KIRKLAND PARKPLACE

Mixed-Use Development

DESIGN RESPONSE CONFERENCE
SUBMITTAL DATE: OCTOBER 16, 2015
PRESENTATION DATE: OCTOBER 19, 2015

PERSPECTIVES FROM DESIGN REVIEW CONFERENCE (OCTOBER 5, 2015)

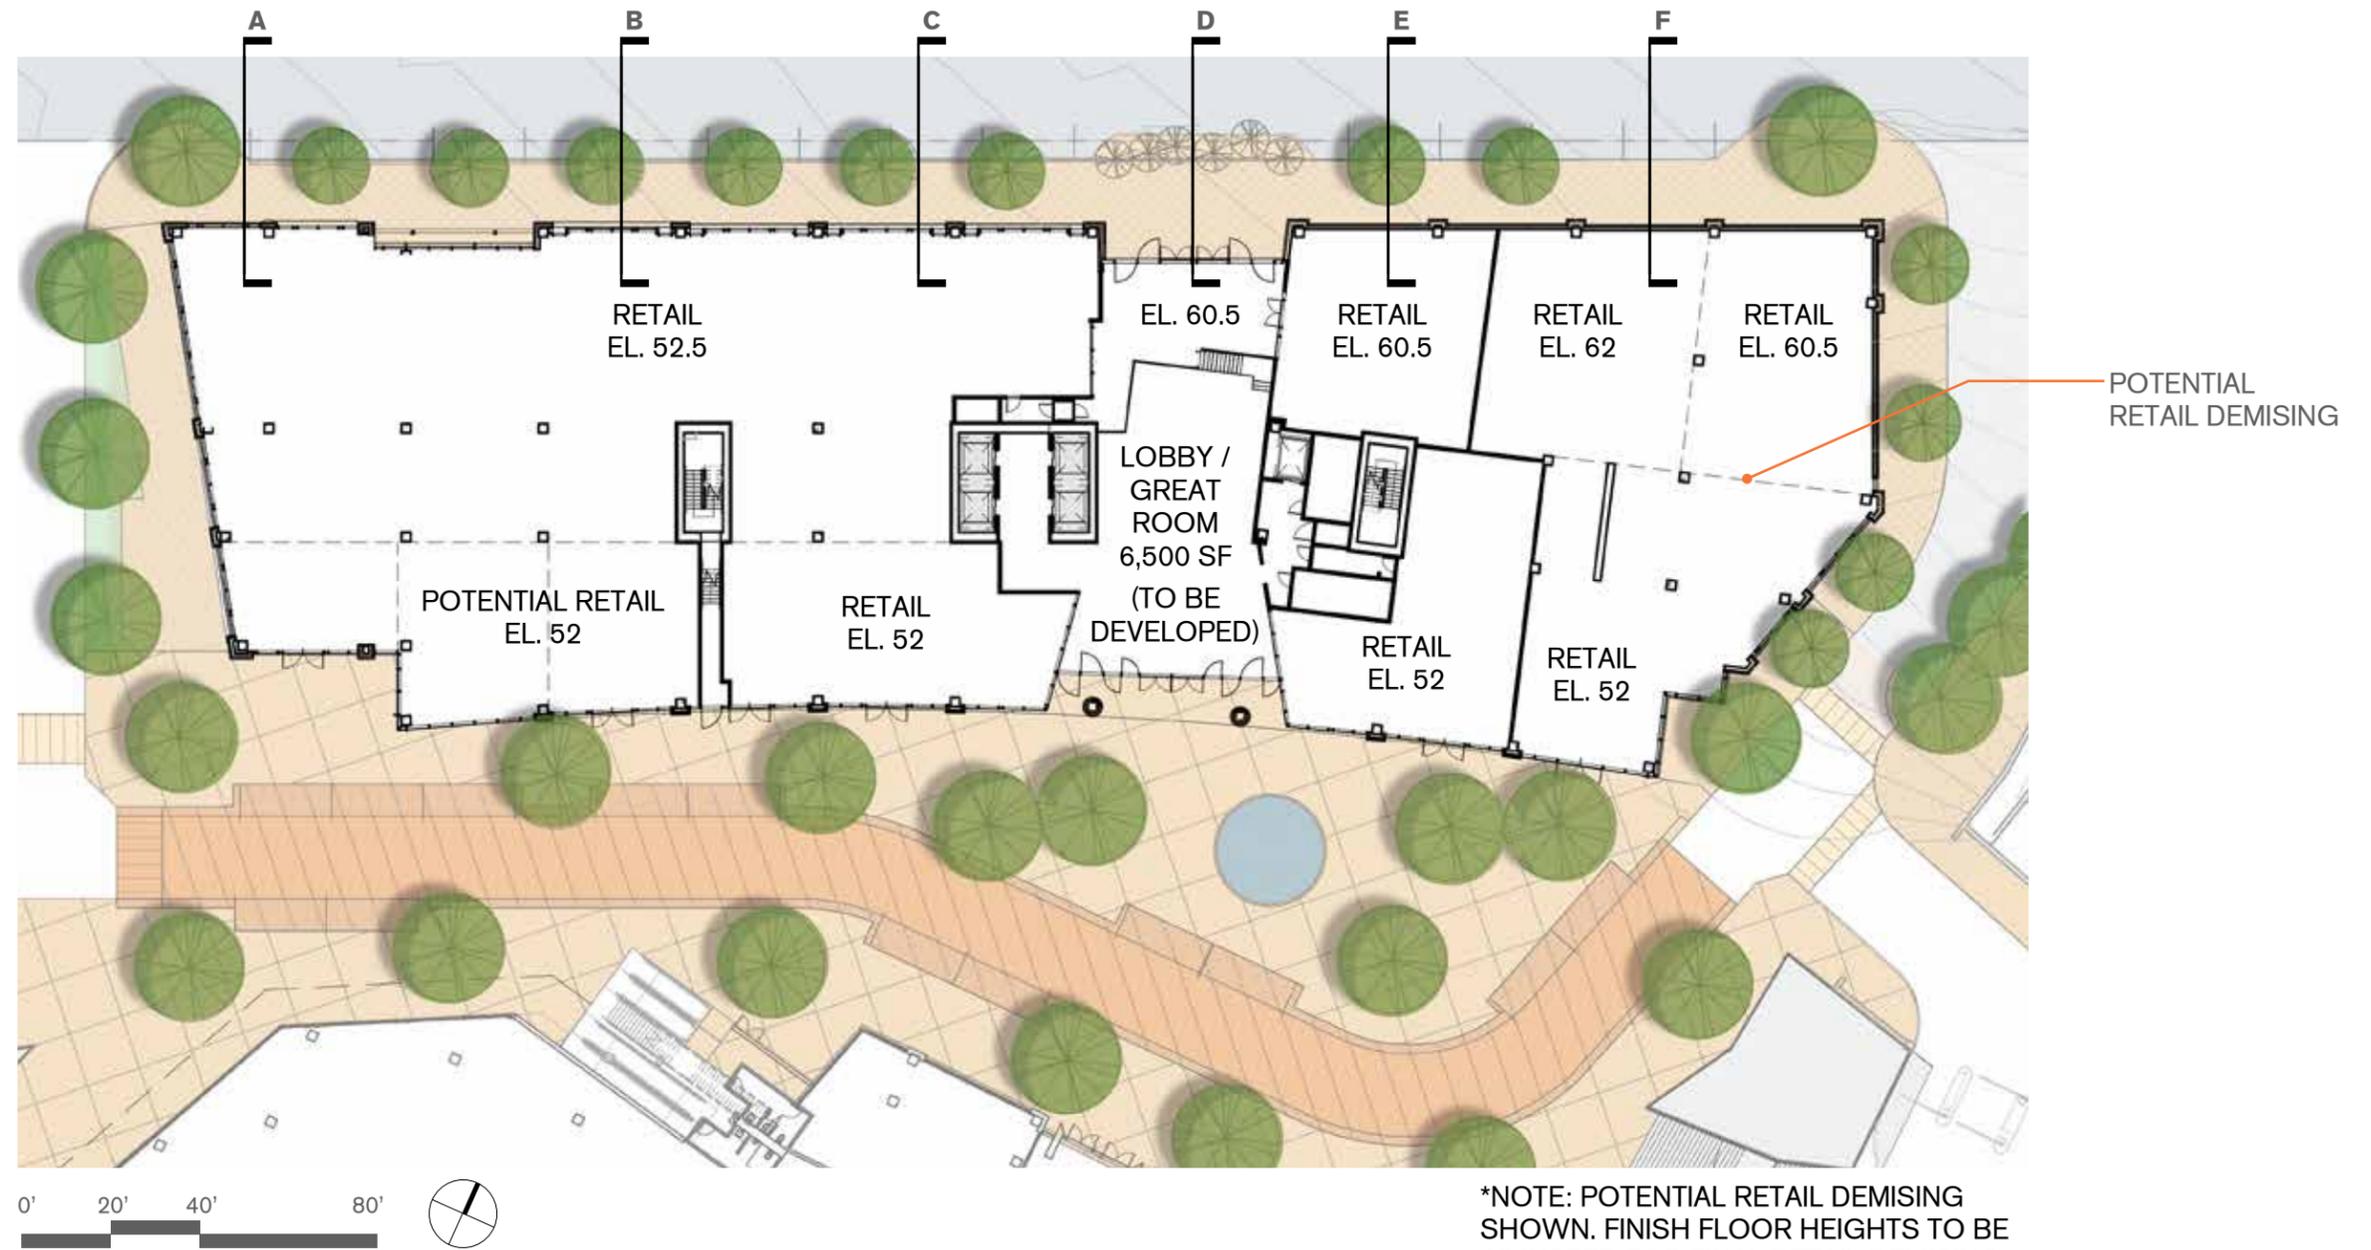
BUILDING E:

Revise the north façade and the upper levels of the east and west façade to address the following concerns:

1. Frame element appears to enhance the scale of the building and is not used elsewhere and therefore looks out of place. Perhaps eliminate or repeat the element to tie it into the rest of the façade.
2. Increase the modulation, and/or add “texture” to the north façade- reduce sense of “flatness”.
3. Demonstrate the retail condition along Central way.
4. Add additional detail to the upper level curtain wall at each end of the north façade. This curtainwall extends the width of the east and west facades and wraps the south façade for one bay. Concern that this looks much like a strip window.
5. Extend roof eyebrow with wood soffit to north façade.
6. Provide sections of the building to address the relationship of retail to grade along Central and to address the building profile at various locations.

The board suggested that design studies and alternatives, including hand sketches and overlays would be appropriate for this discussion.
